**SANTA CRUZ AVENUE/ALAMEDA DE LAS PULGAS
COMPLETE STREET PROJECT
AVY AVENUE TO SAND HILL ROAD**

**COUNTY PROJECT NO. RW934
PROJECT FILE NO. E5043
STATE FUND NO. ATPL-5935(090)**

ADDENDUM NO. 3

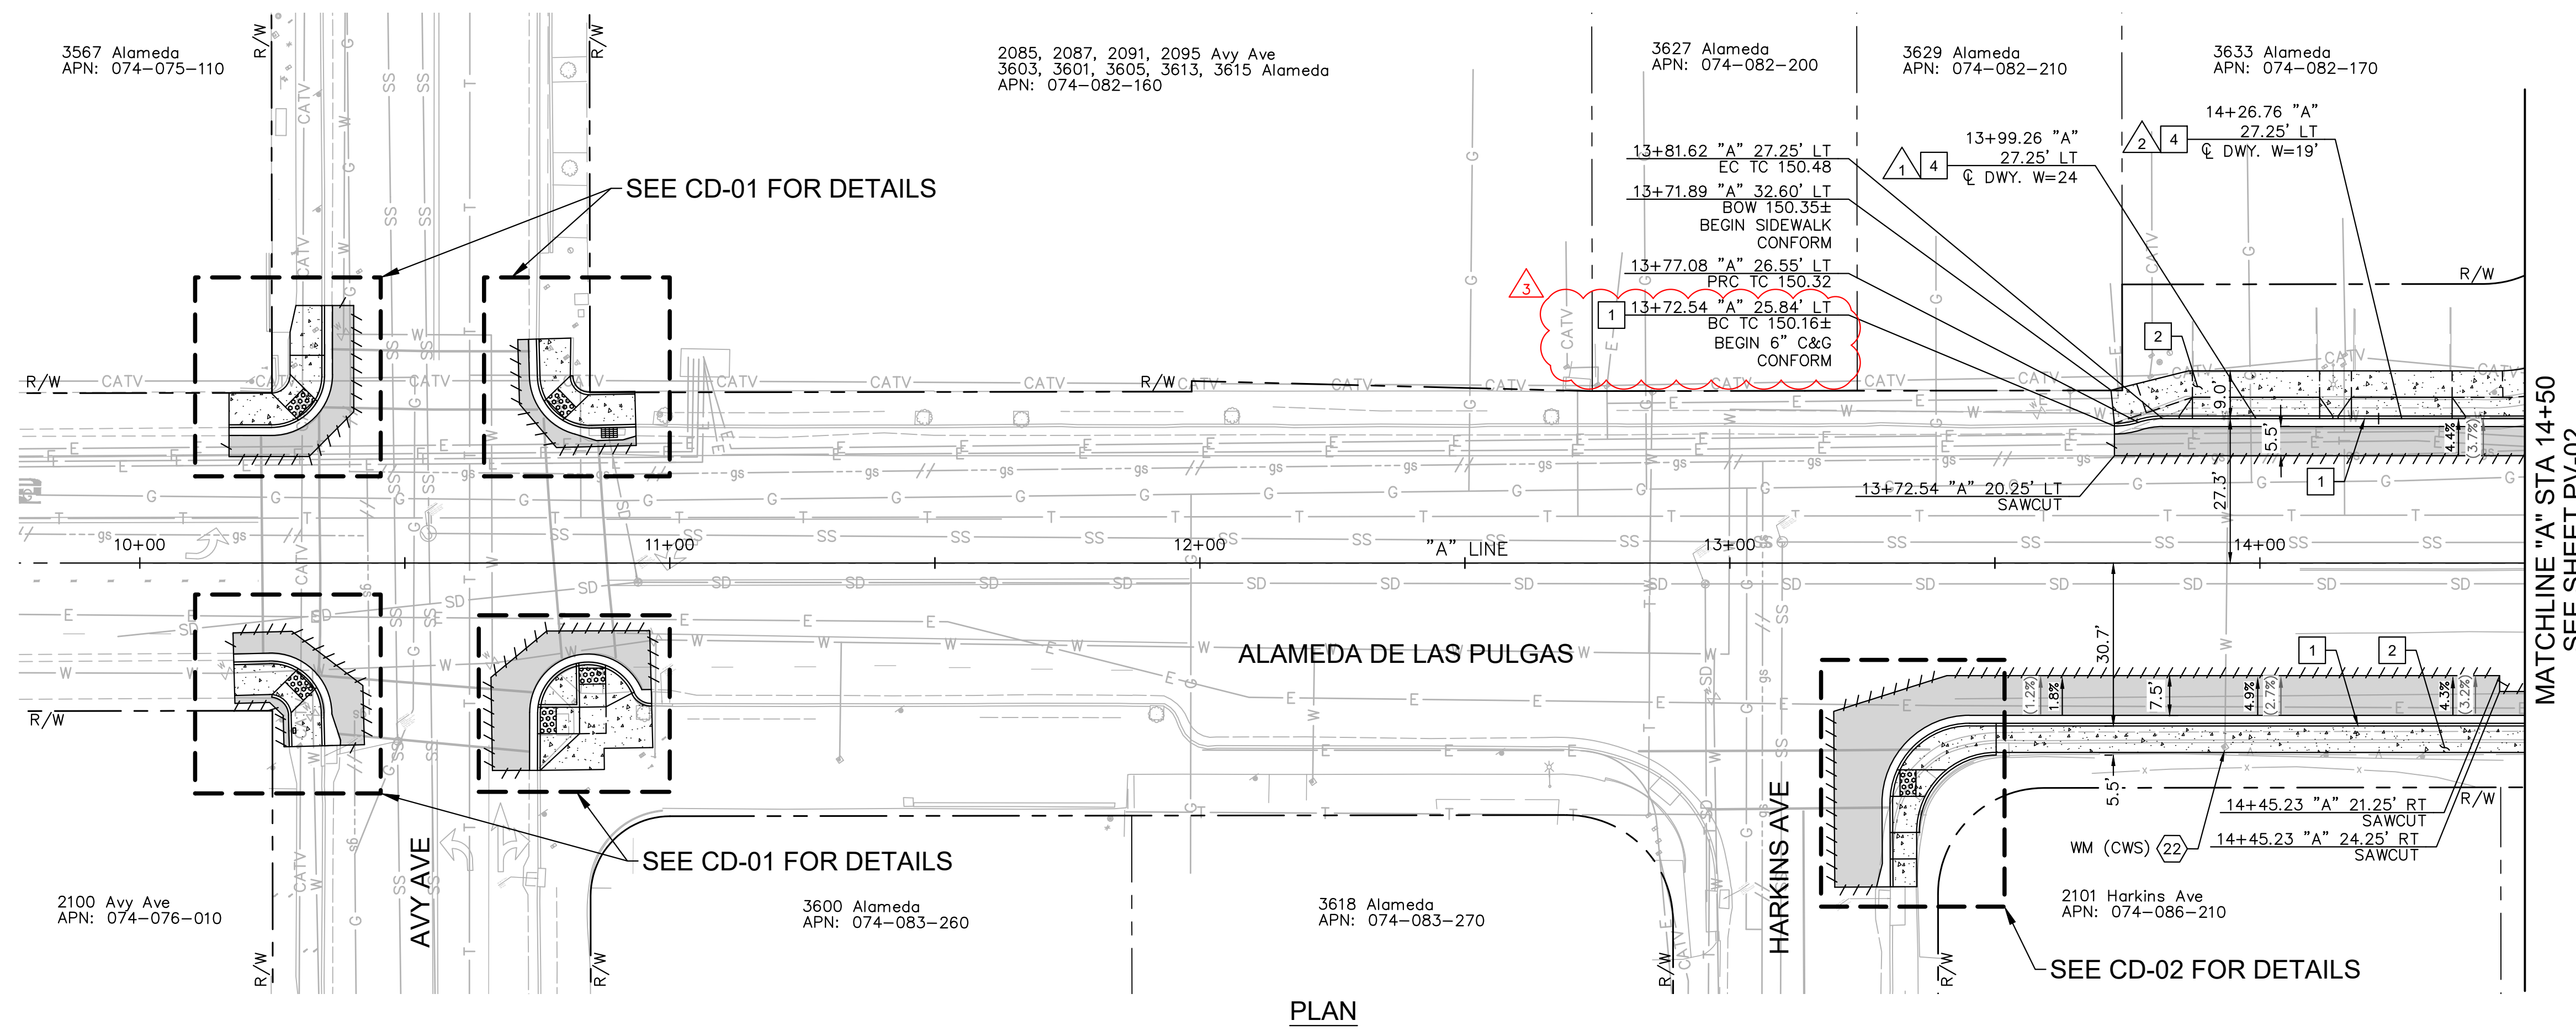
- CONTRACTOR SHALL PROVIDE A MINIMUM OF 48 HOURS NOTICE PRIOR TO REQUESTED INSPECTION REQUESTS.
- ~~CONTRACTOR'S BID PRICE SHALL INCLUDE ALL INSPECTION FEES.~~ **NOTE DELETED.**
